Kinsale Road LRD, Kinsale Road, Cork

Planning Engineering Report

214130-PUNCH-XX-XX-RP-C-004

2.2 Problem:

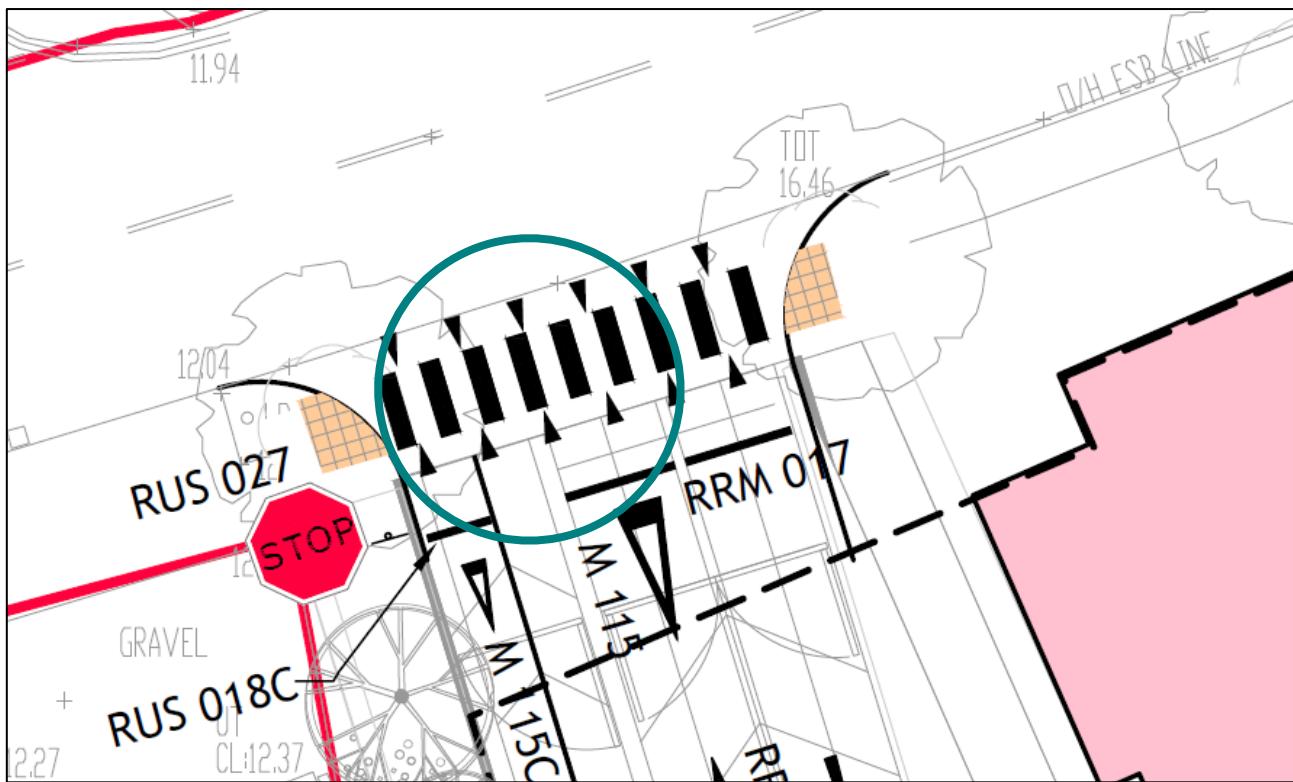
The proposed layout of the two-way cycle facility on one side of the access road to the underground car park at its junction with Pearse Road may increase the risk of conflicts between cyclists turning into the access road and motorists exiting the access road.

2.3 Problem:

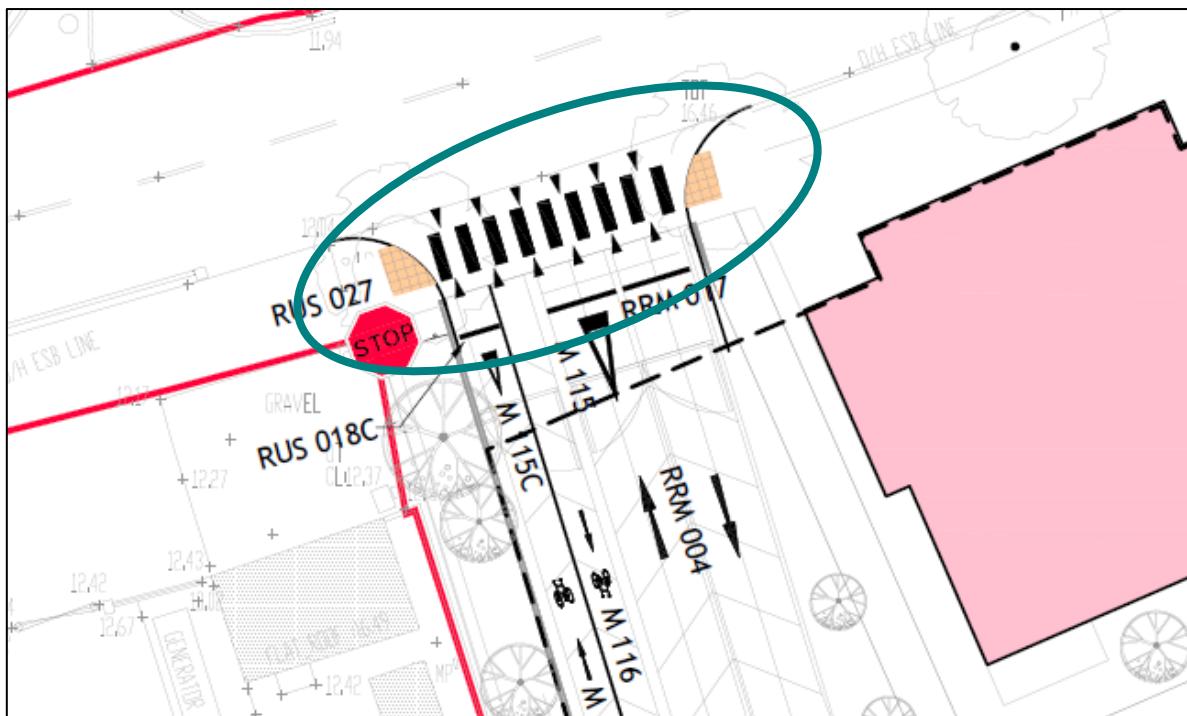
Zebra bar markings are proposed across the junction mouth at the Pearse Road access to the proposed development. However, no signs or belisha beacons are proposed while the tactile paving proposed is for an uncontrolled crossing. Such a layout may confuse both motorists and pedestrians as to who has priority at the crossing which could contribute to a pedestrian collision at this location. The provision of a zebra crossing at this location may also increase the risk of a rear end collision with a following vehicle, if a driver turning left from Pearse Road has to give way to a pedestrian on the crossing, as the following driver may not expect the vehicle ahead to stop on Pearse Road.

2.4 Problem:

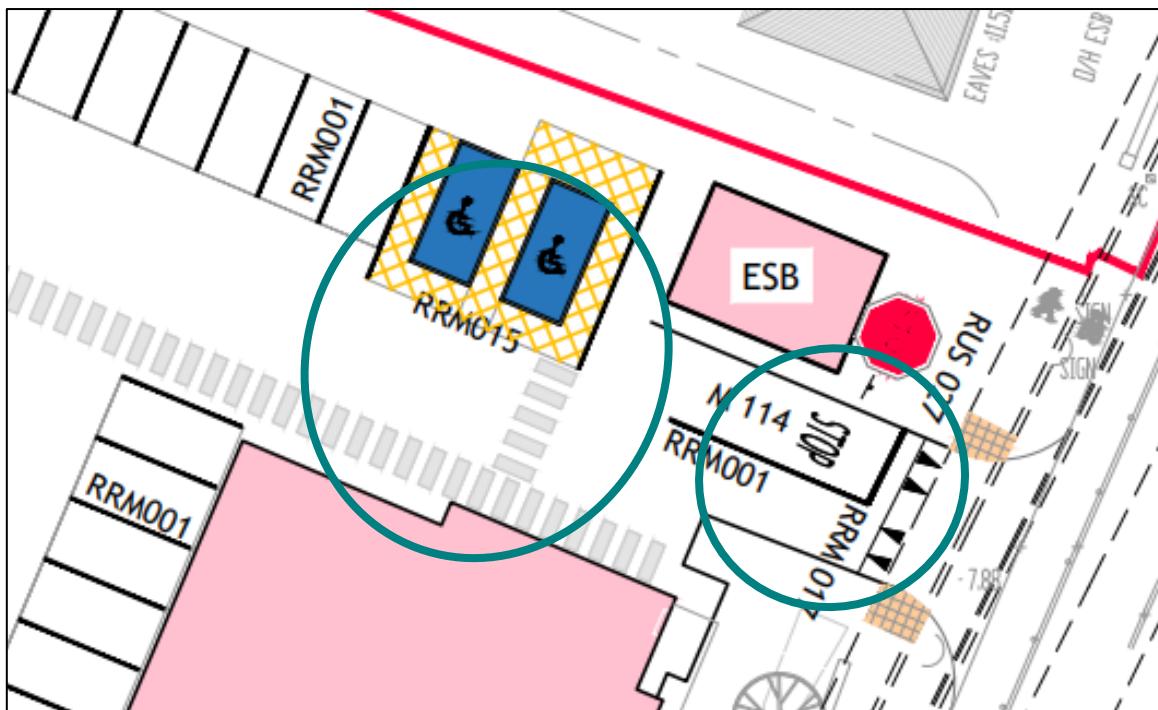
The width of the access road immediately inside the access onto the Kinsale Road appears to be narrow. In addition, the proposed internal access road changes direction abruptly immediately downstream of this location in order to facilitate parking spaces along the north side of the access road. The layout of the access road at this location may contribute to side swipe collisions with opposing vehicles or pedestrian collision with VRUs using the disabled parking spaces or pedestrian walkway.

2.5 Problem:

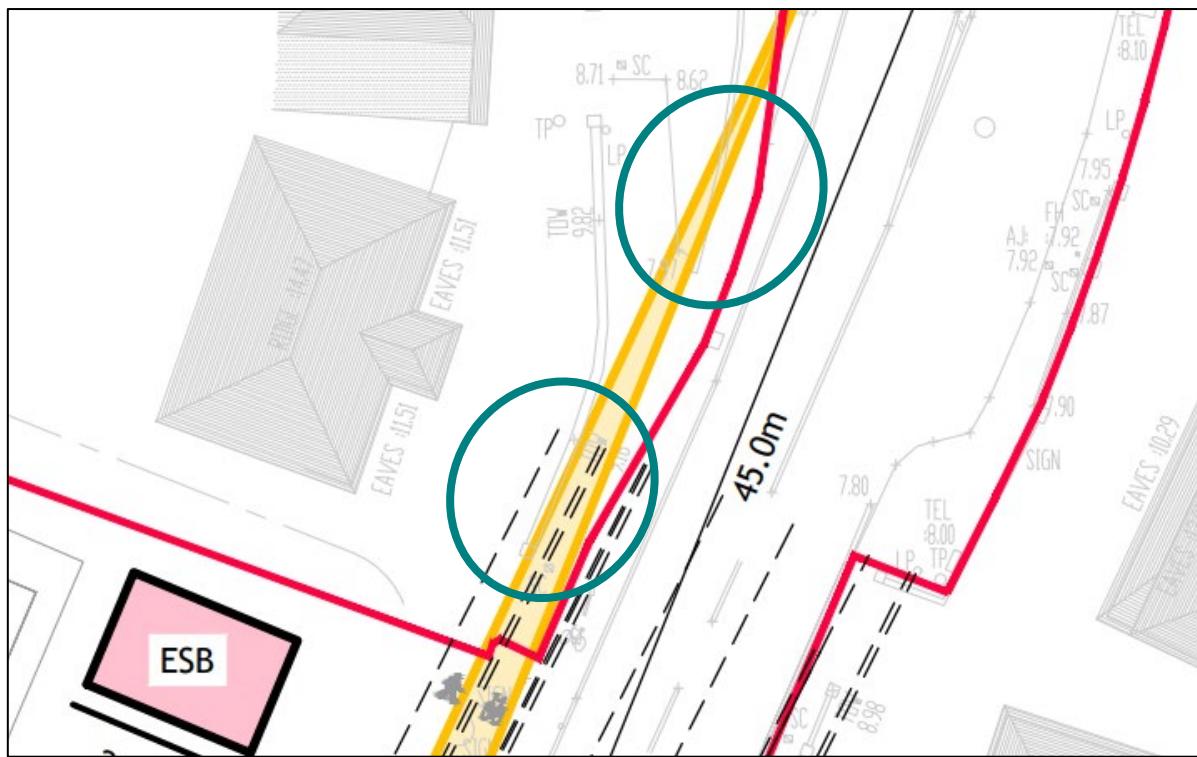
The visibility splays to the left from the proposed eastern access from the development appears to be obstructed by existing boundary walls. Road safety risk is increased in situations where inter-visibility between drivers turning out of an access and drivers approaching on the mainline is restricted. Lack of adequate visibility may increase the likelihood of a collision at the access.

2.6 Problem:

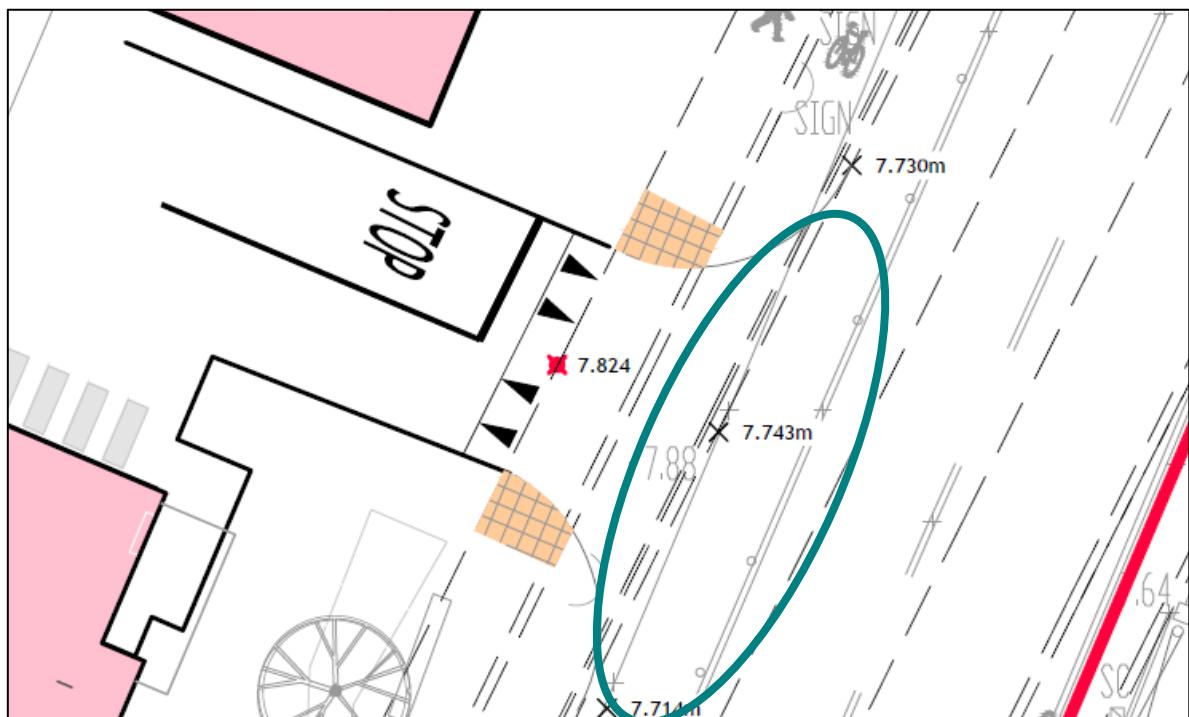
Priority between cyclist using the existing cycle lane and motorist turning at the Kinsale Road access may be unclear in advance of the future junction layout being implemented. A lack of clear priority at this location may contribute to a cycle collision at this location.

2.7 **Problem:**

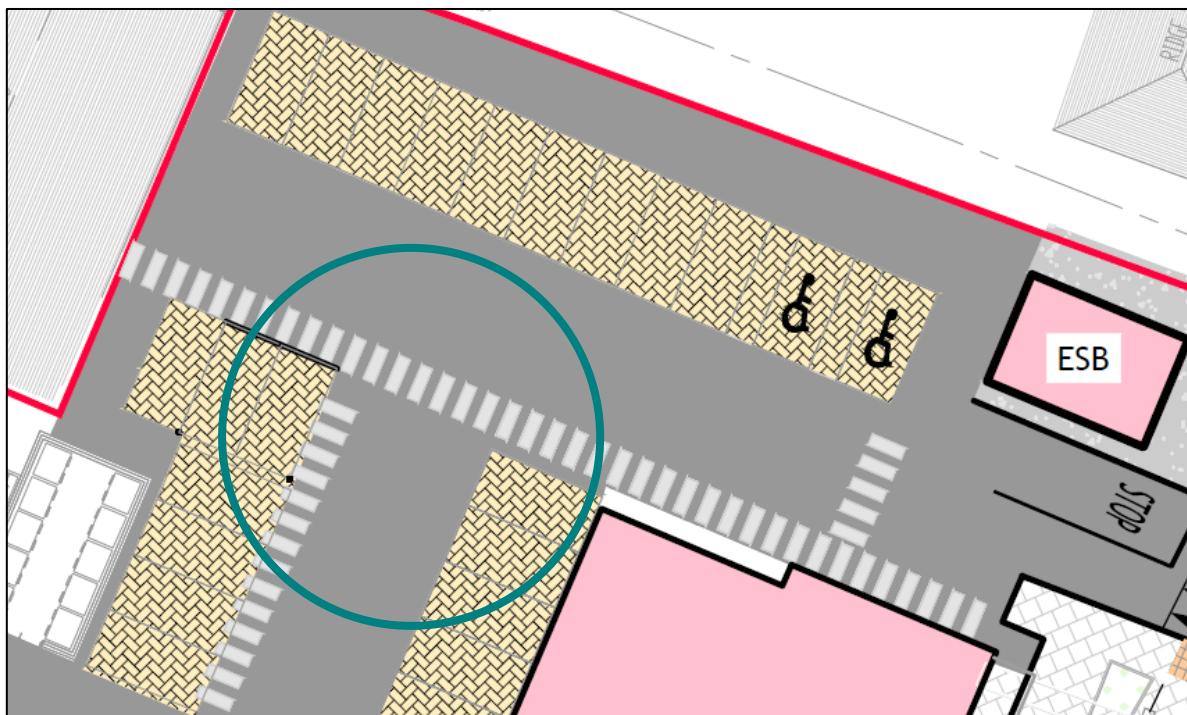
Road markings or traffic signs to indicate junction priority are not shown to be provided at the proposed internal junctions. This may lead to turning collisions if priority at the junctions is unclear to drivers.

2.8 **Problem:**

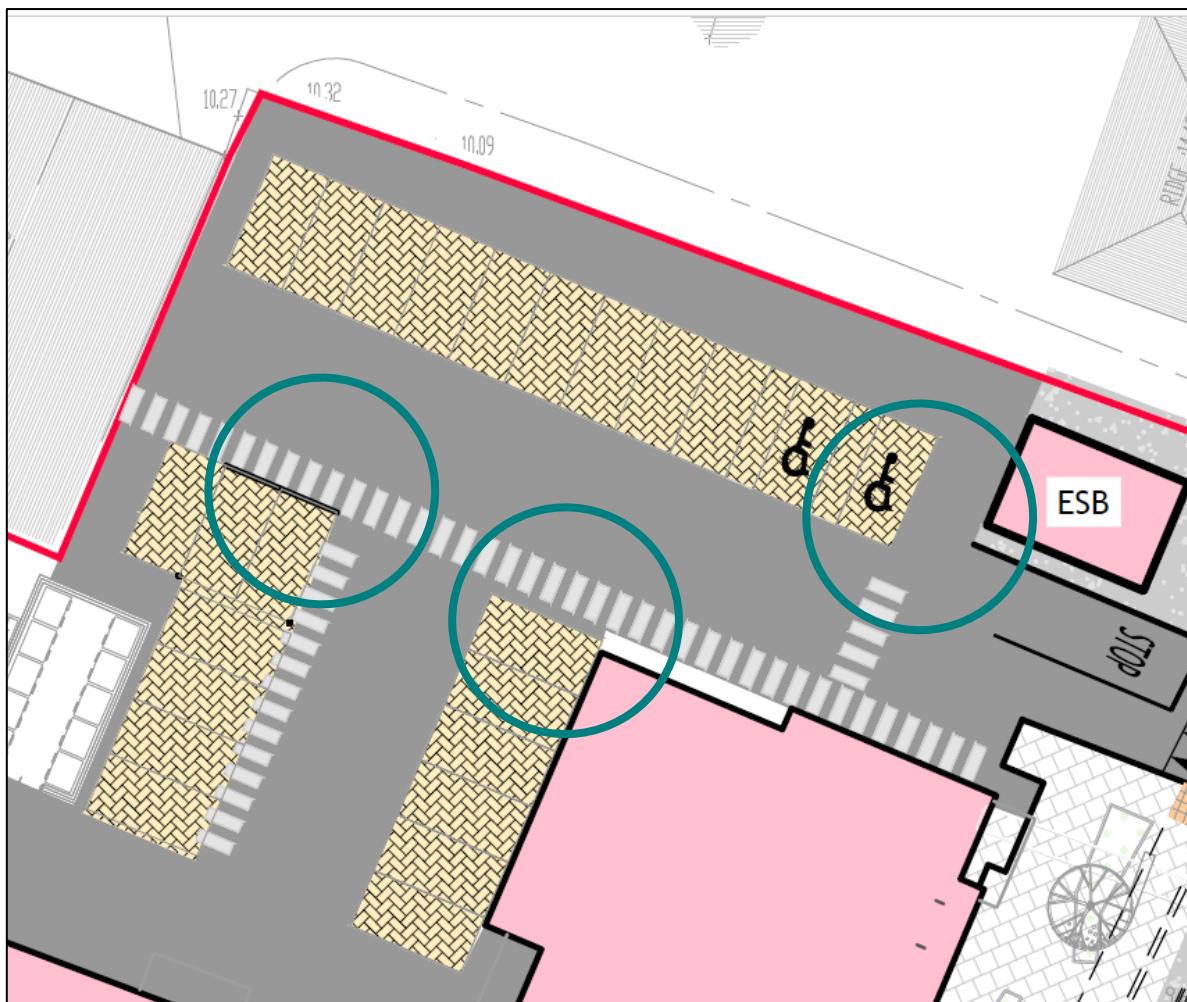
Intervisibility between pedestrians crossing pedestrian crossings at the locations shown below and drivers of vehicles approaching the crossings may be restricted by vehicles parked in the adjacent parking spaces. A lack of adequate intervisibility may contribute to a collision at these locations.

2.9 Problem:

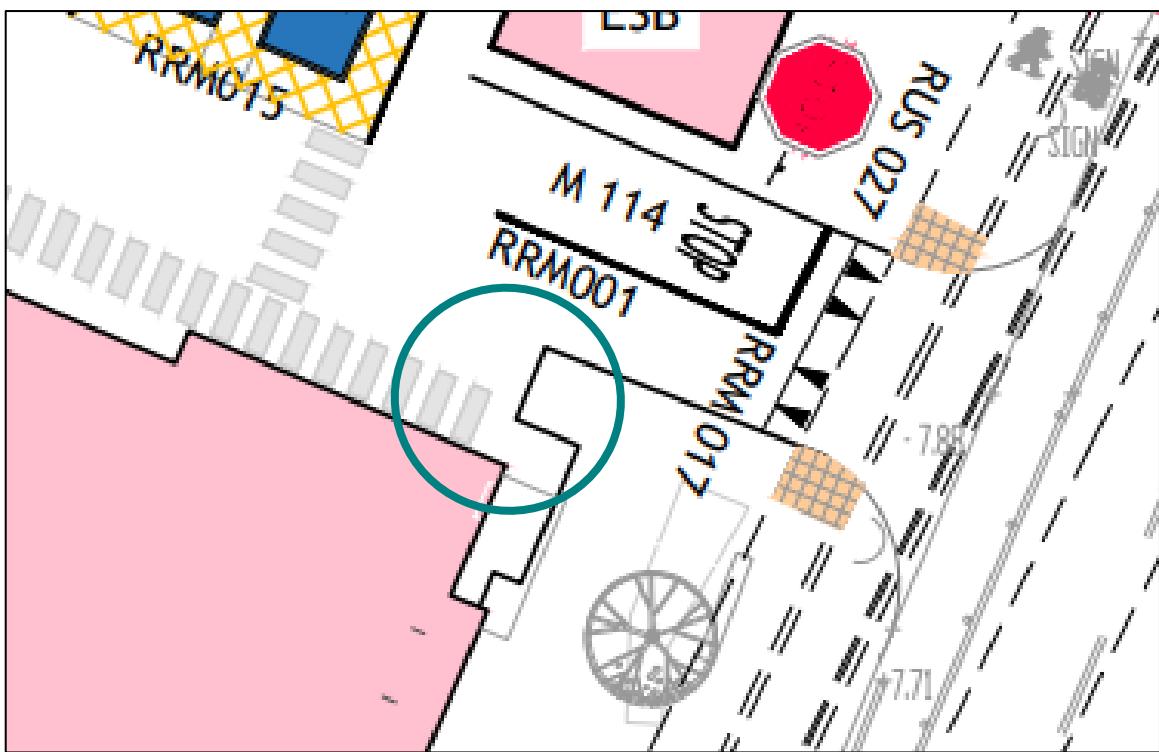
Ramps are indicated along the footpaths and cycle tracks at a number of locations. However, the slopes are not identified. Excessive slopes may be difficult for pedestrians, especially those with mobility aids, to navigate and may lead to trips, slips and falls.
